SUBJECT: ISSUANCE OF AMENDMENT NO. 71 TO FACILITY OPERATING LICENSE NPF-35  
AND AMENDMENT NO. 65 TO FACILITY OPERATING LICENSE NPF-52 - CATAWBA  
NUCLEAR STATION, UNITS 1 AND 2 (TACS 75484/75485)

The amendments revise TS 3.1.3.5, Figure 3.1-1, and Basis 3/4.1.3 to modify the fully withdrawn control rod bank insertion limits from 228 steps to at least 225 steps.

SAFETY EVALUATION BY THE OFFICE OF NUCLEAR REACTOR REGULATION  
RELATED TO AMENDMENT NO. 71 TO FACILITY OPERATING LICENSE NPF-35  
AND AMENDMENT NO. 65 TO FACILITY OPERATING LICENSE NPF-52  
DUKE POWER COMPANY, ET AL.  
CATAWBA NUCLEAR STATION, UNITS 1 AND 2  
DOCKET NOS. 50-413 AND 50-414

FIGURE 3.1-1  
ROD BANK INSERTION LIMITS VERSUS THERMAL POWER  
FOUR LOOP OPERATION

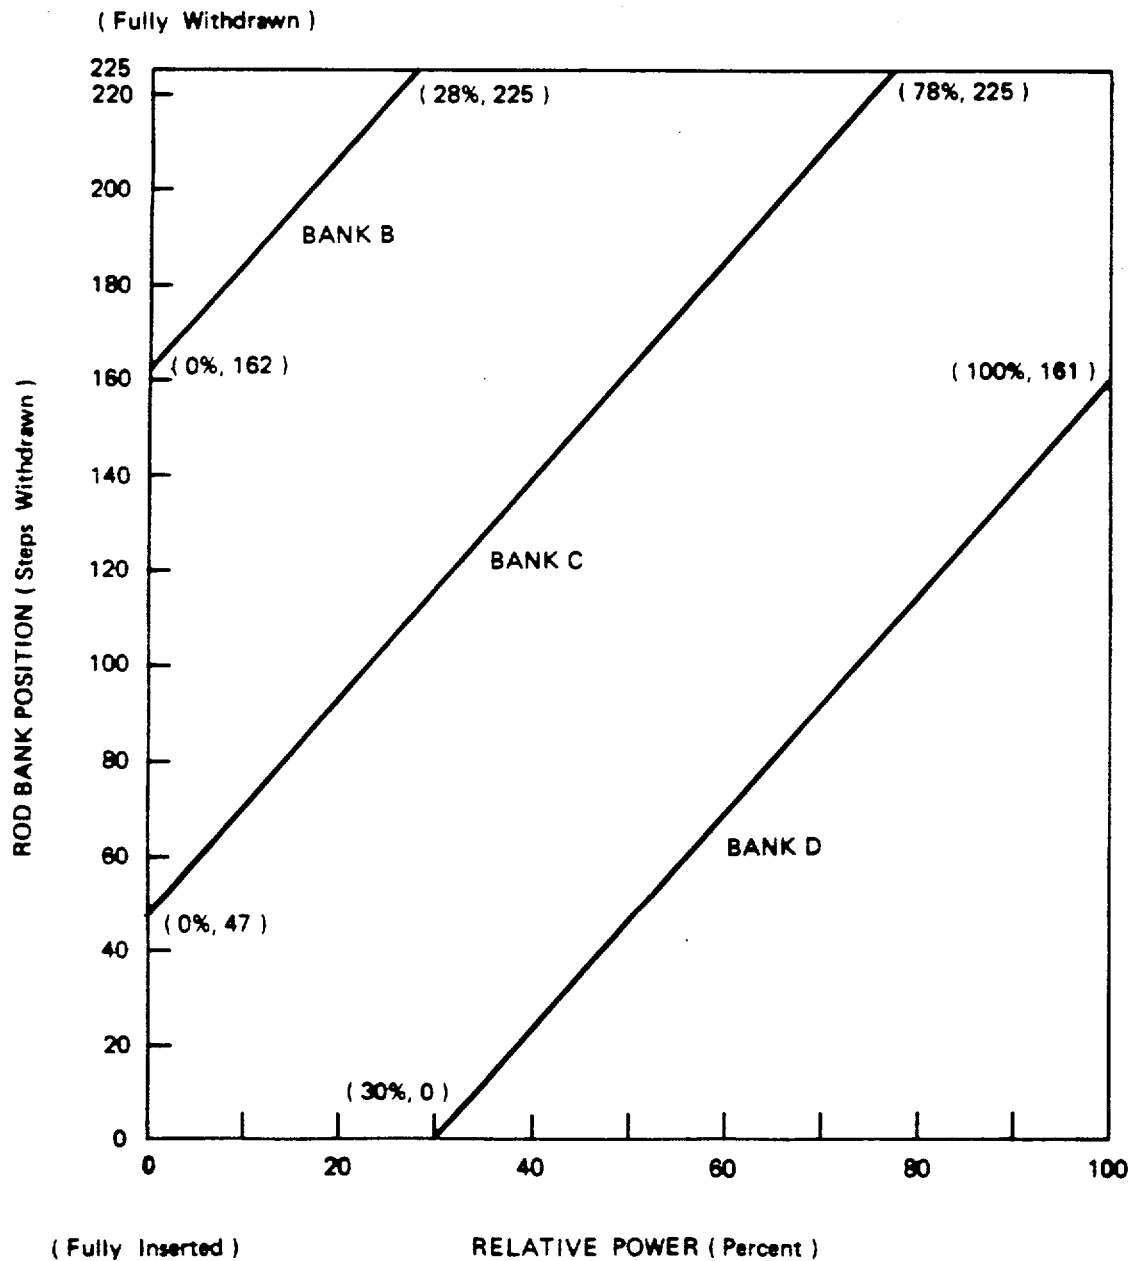
By letter dated November 10, 1989, Duke Power Company, et al. (the licensee), proposed amendments to Catawba Nuclear Station, Units 1 and 2, Technical Specification (TS) 3.1.3.5, "Shutdown Rod Insertion Limit," and Figure 3.1-1, "Rod Bank Insertion Limits versus Thermal Power Four Loop Operation." Specifically, the definition of "fully withdrawn" is changed from "228 steps withdrawn" to "at least 225 steps withdrawn." Additionally, TS Basis 3/4.1.3 is revised to provide justification for the TS change.

The licensee proposed the above TS revision to minimize localized rod cluster control assembly (RCCA) wear and to extend its life. Unusually high wear rates have been reported in 17x17 RCCAs at several domestic and foreign Westinghouse plants. The observed wear is the result of flow induced vibratory contact between RCCA rodlets and upper internals guide cards when the RCCAs are parked in the fully withdrawn position. The proposed TS revision permits axial repositioning within the range of "225 steps fully withdrawn" to "230 steps fully withdrawn" (the mechanical withdrawal limit for the control rod drives). As a result, already worn rodlet cladding surfaces can be shifted away from the guide cards.

The licensee's analysis of the proposed TS change indicates that its impact on key safety parameters is negligible and bounded by the Final Safety Analysis Report (FSAR) accident analyses. The slight increase in rod drop time (0.018 seconds) at the "230 step fully withdrawn" position is accommodated by the available margin (1.8 seconds). Also, sufficient excess shutdown margin exists to compensate for the approximately 30 pcm decrease at the "225 steps fully withdrawn" position. The maximum positive reactivity insertion rate resulting from an uncontrolled RCCA bank withdrawal from a subcritical or low power startup condition, as well as at power, is negligibly changed by the proposed TS revision and remains bounded by the accident analyses. RCCA ejection accidents at the "225 step or greater fully withdrawn" position are also bounded by existing analyses. In addition, the revised axial power distribution resulting from the proposed change is accommodated by the available

peaking factor margin and remains within the established TS limits. At the "225 steps fully withdrawn" position, a maximum decrease of 50 pcm in trip reactivity worth results from the proposed change. To compensate for this slight decrease, the licensee has stated that a 75 pcm penalty will be considered in all trip reactivity calculations.

Based on its review, the NRC staff finds that the proposed change would have a negligible impact on safety and would not pose an undue risk to the public health and and safety. Therefore, the change is acceptable.
